C. The Bureau Erred in Allowing Increased ATC Base Station Power and Relaxing Base Station Antenna Performance Requirements

Technical Annex – December 8, 2004

1. Downlink Interference Issues

Figure 1: Impact of Relaxing the Overhead Gain Suppression of the ATC Base Stations on the Safe Distance of an Aircraft from the ATC Base Station (-75 dBm interference threshold)

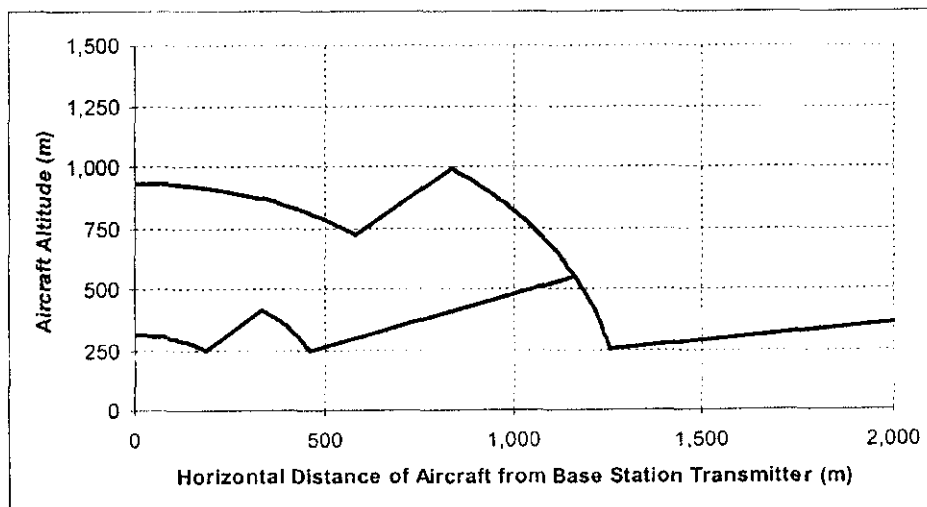
In its ATC opposition in March 2004, Inmarsat demonstrated, by analysis of a single ATC base station, the impact on aircraft of granting this waiver---the resulting increase in the safe height an aircraft would need to maintain above an ATC base station.⁹ The key result is shown in Figure 1 below, which clearly shows in the upper line (for horizontal distances less than approximately 1,200 meters) the increased safe distance of the aircraft from the base station resulting from grant of the requested overhead gain suppression waiver, compared to the lower line which gives the safe distance assuming compliance with the gain suppression values and other limits in the ATC rules. Note that, for the situation analyzed in Figure 1, for horizontal distances greater than approximately 1,200 meters and altitudes greater than approximately 500 meters, the ATC base station antenna gain is not affected by the proposed relaxation. Although the Bureau accurately summarized this analysis at one point,¹⁰ it subsequently dismissed these results based on its determination that this represented an “unexplained contention” by Inmarsat.¹¹

Inmarsat’s analysis and position on this matter cannot be ignored as “unexplained”. It was clearly presented in Inmarsat’s opposition and it was derived from a straightforward calculation of the interfering signal arriving at the aircraft from the base station. The assumptions about the interference susceptibility of the Inmarsat receiver were also clearly stated to be -75 dBm at its input, as supported by the report from Honeywell that Inmarsat included as Appendix C to its Opposition.

Figure 2: Impact of Relaxing the Overhead Gain Suppression of the ATC Base Stations, and Increasing its EIRP by 8 dB, on the Safe Distance of an Aircraft from the ATC Base Station (-50 dBm interference threshold)

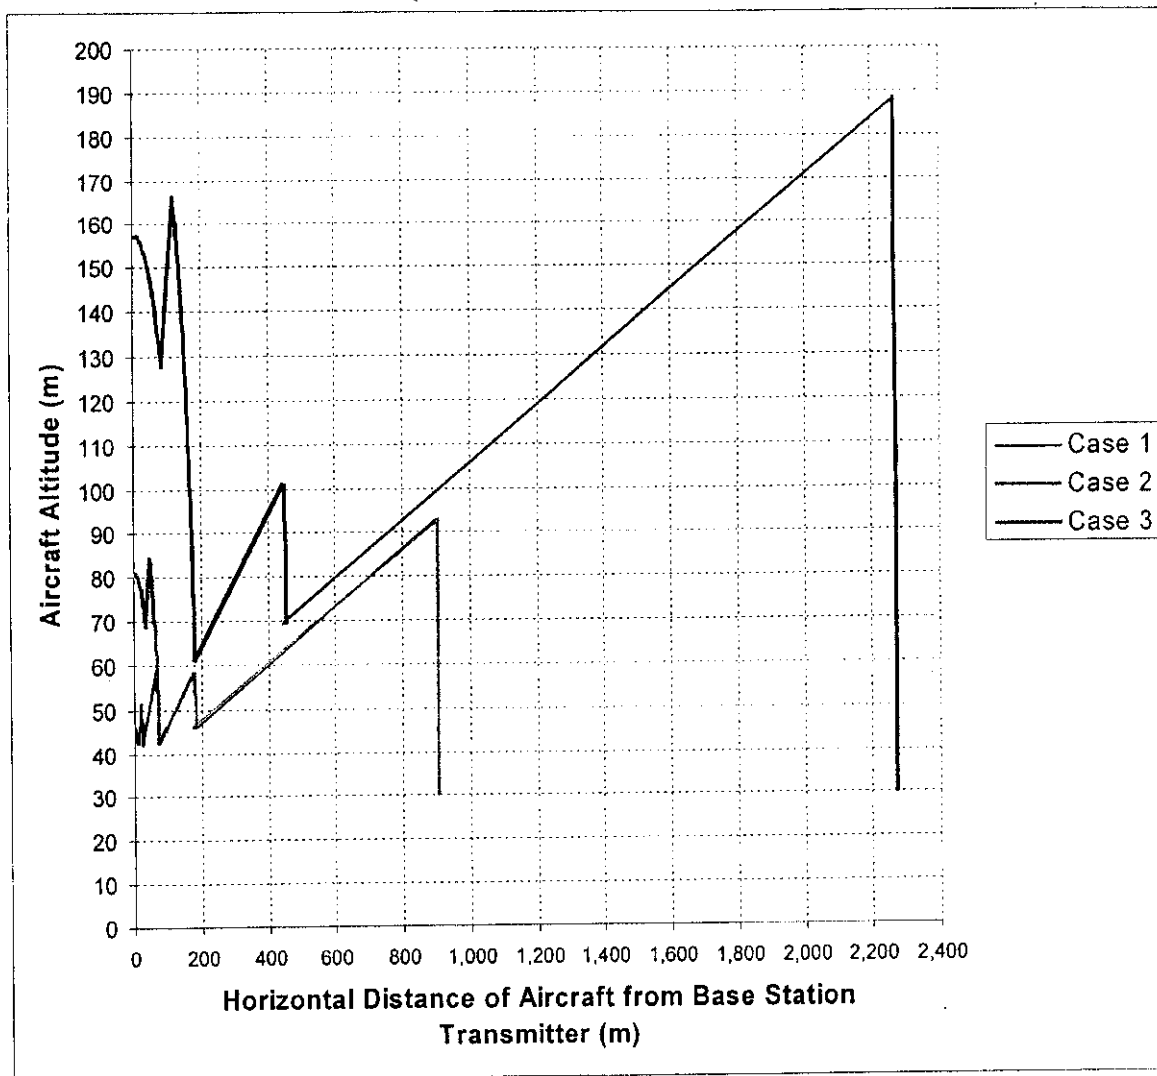
The results of the combined effect of the Bureau's waiver grants are shown in Figures 2 and 3 below, where the necessary separation distances are given in terms of the altitude and horizontal distance from the aircraft to the ATC base station, as for Figure 1 above. Figure 2 assumes the -50 dBm interference threshold level that the Bureau proposes to use for this analysis. Figure 3 shows the same information, but with the -75 dBm interference threshold that Inmarsat believes should be used based on data from its manufacturers, as previously presented. On both of these Figures, Case 1 is the result using the limits in the ATC rules. Case 2, which only differs from Case 1 over a limited horizontal separation distance, is the result when the ATC overhead antenna gain suppression is relaxed by the 8-10 dB. Case 3 is the result when the ATC overhead antenna gain suppression is relaxed by the 8-10 dB *and* the ATC base station EIRP is relaxed by 8 dB. Note that in both Figure 2 and Figure 3 there is a dramatic increase in the vertical distance separation required when the aircraft is over the ATC base station.

In assessing the results in Figures 2 and 3 we must keep in mind that these results are for the interference from a single ATC base station only, and that the aggregate interference from more than one ATC base station, which will likely occur simultaneously, as assumed by the Commission in the *ATC Order*, will be correspondingly worse. With this in mind, Figure 2 already shows a significant interference problem, despite the assumption of a very high interference threshold (-50 dBm). In fact, even without any change in the FCC limits, the interference distance to aircraft at an altitude of 90m is greater than the distance limitation of 470m. With the relaxations in base station EIRP and overhead gain suppression, harmful interference will occur from a single ATC base station when the aircraft altitude is less than 190 meters (623 ft) and at horizontal distances up to 2,250 meters (1.4 miles). The results in Figure 3, which assumes the interference threshold of -75 dBm, as evidenced by Inmarsat's aeronautical terminal manufacturers, are very much worse, with interference problems occurring at aircraft altitudes up to 2,800 meters (1.7 miles) and horizontal distances up to 40 km (25 miles). Clearly, the FCC's proposed distance separation limits and PFD limits relative to airports, even if these are modified to account for any correction in the interference threshold, will have absolutely no impact on overcoming the interference caused by the combination of relaxing the overhead gain suppression requirements and increasing ATC base station EIRP. These results demonstrate that the combination of the two relaxations proposed by the Bureau would have a serious impact in terms of interference into airborne terminals. Therefore, it is essential that the Commission correct the error made in granting the waivers to MSV.

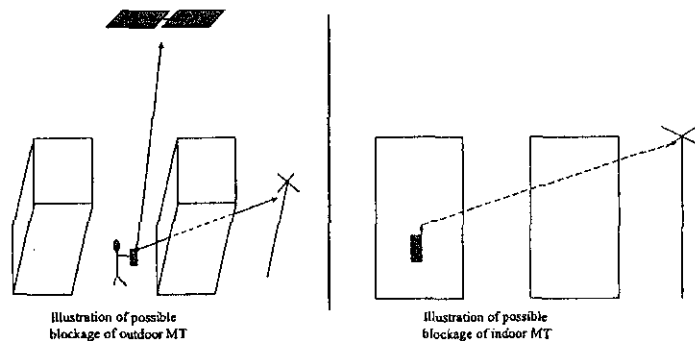
Clearly, the actual equivalent outdoor EIRP of different MTs will vary depending on the MTs operational conditions, i.e. mainly its location with respect to the ATC base station. For example, the requirement referred to above means that MTs at the edge of a cell with line-of-sight to the base station will have an equivalent outdoor EIRP of -18 dBW (or less). MTs inside a cell (but still in line-of-sight conditions) will have somewhat lower equivalent outdoor EIRP. Furthermore, particularly in urban environments, there is a high probability that MTs used outdoors are fully or partially blocked from the ATC base station. It should be noted that also indoor MTs and MTs operated in cars may be subject to additional blockage towards the base station. These situations are illustrated in the diagram below. The critical issue is to ensure that the average equivalent outdoor EIRP for **all** ATC MTs operating on the same frequency is -20 dBW or lower.

In the situation shown in the diagram above, the MT may have to operate at full EIRP to close the link to the base station. In the case of outdoor MTs, as shown in the left part of the diagram above, and taking into account the MT antenna pattern supplied by MSV, the EIRP towards the Inmarsat satellite would then be -4 dBW. This situation would only need to exist simultaneously, at the same frequency, 69 times across the entire USA, to cause the equivalent interference of 1,725 frequency re-uses under the conditions assumed in the Commission's uplink interference analysis as contained in the *ATC Order*. Furthermore, it is apparent from the diagram above that the interference potential from these particular MTs could be even greater than that. If the 3.1 dB outdoor blockage does not apply to these particular MTs, the situation would only need to exist 34 times to cause the same interference level.
